FINAL
GENERIC ENVIRONMENTAL STATEMENT ON THE
ROUTINE USE OF PLUTONIUM-POWERED
CARDIAC PACEMAKERS

NUCLEAR REGULATORY COMMISSION
OFFICE OF NUCLEAR MATERIAL
SAFETY AND SAFEGUARDS

Issued: July 1976

Figure 2

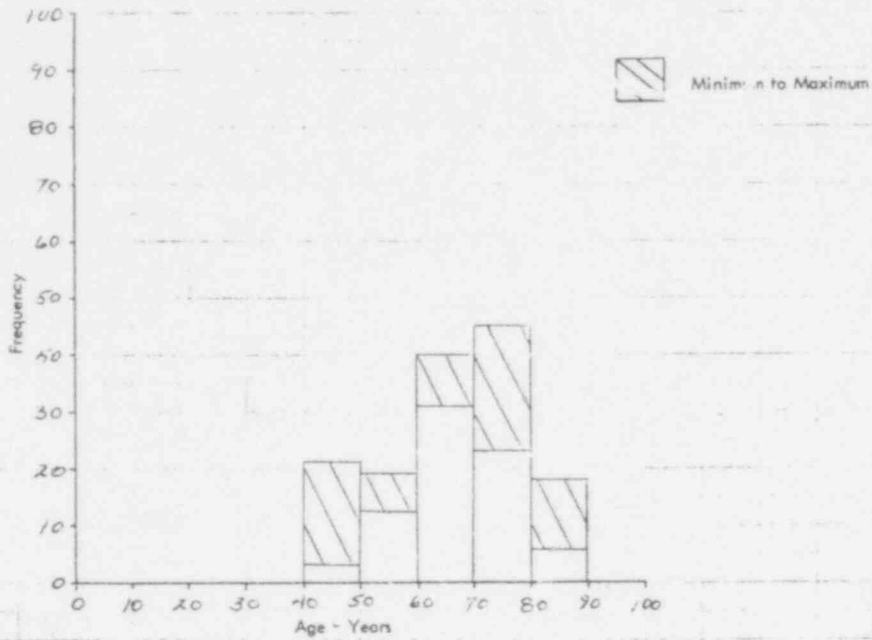
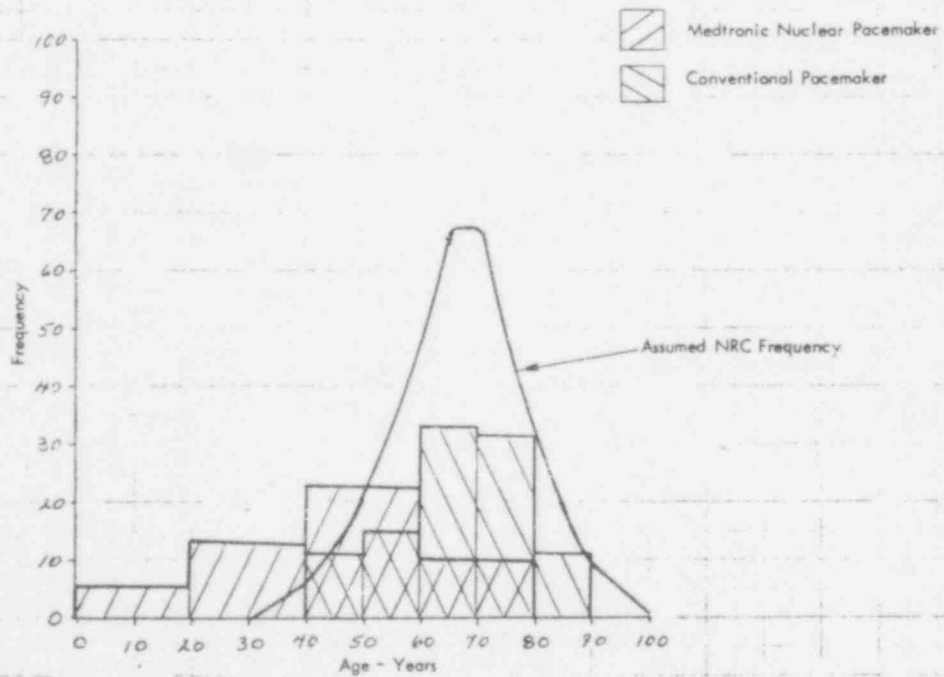
Figure 2 shows the normalized age group of the four populations previously discussed with the assumed NRC frequency⁽²⁾ utilized in this benefit analysis. Also shown on Figure 2 is the age frequency for nuclear pacemakers as experienced by Medtronic Inc.⁽³⁾ It is important to note that the age frequency for nuclear pacemakers is for a much younger patient population than either the surveyed populations (Figure 1) or the NRC assumed age distribution. This is more readily apparent on Figure 3 which shows the distribution of the age frequency. Note the distribution assumed by the NRC and the four surveyed populations (Figure 1) are identical. However, the age distribution for the nuclear pacemaker population is markedly different. The median age of a conventional pacemaker bearer is 68 years, while the median for a nuclear pacemaker bearer is 46 years! This represents an enormous disparity when considering longevity benefits.

Also shown on Figure 3 are two isolated points for conventional pacemaker bearers.⁽⁴⁾ These represent the latest available data on age distribution. They are an indication of a trend generally realized in the pacemaker industry, that the average age of all pacemaker bearers is decreasing.

Figure 5. The Dependence of Dose and Dose Rate Regarding the Destruction of Organ Functions

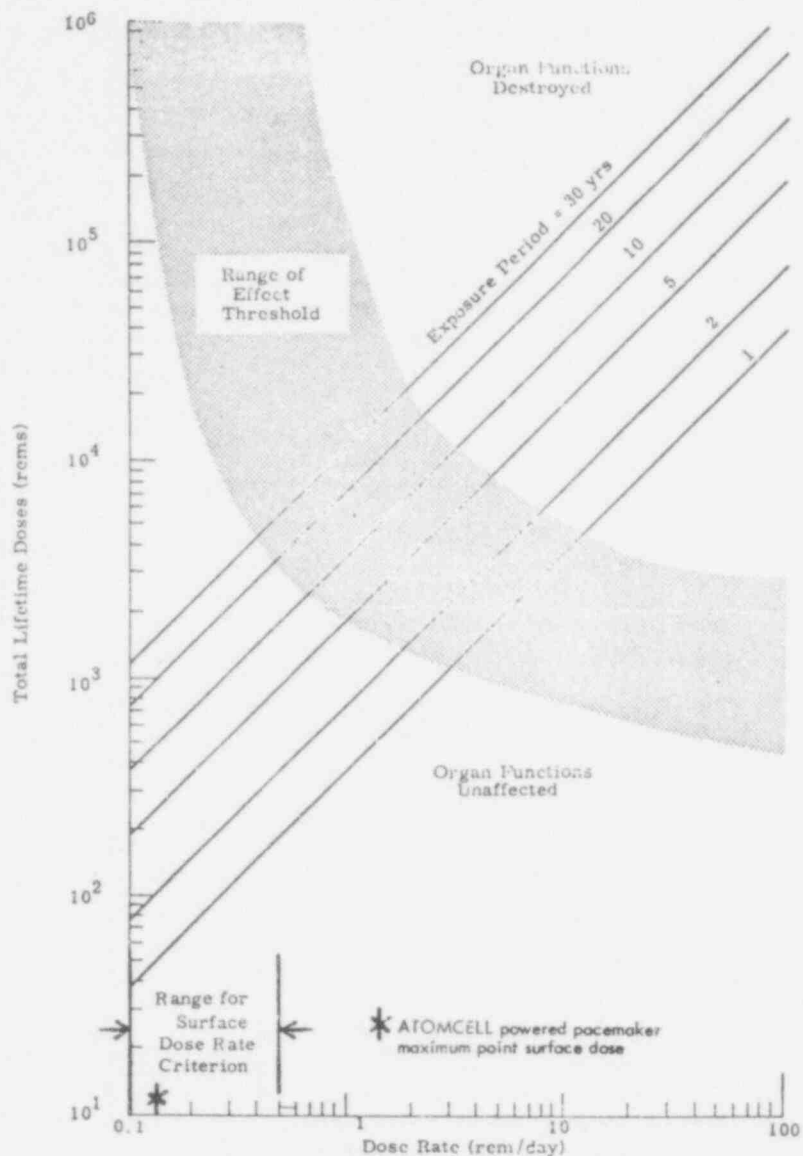
Therefore, placed in the proper context, the plutonium powered pacemaker radiation levels should not be of concern. We previously submitted a fairly extensive report⁽¹⁶⁾ to the NRC showing that based upon all the experimental evidence we were able to find in the literature that there would be no organ effect from radiation up to 25 millirem per hour for a 30-year exposure. This is summarized in Figure 5 of this submittal.
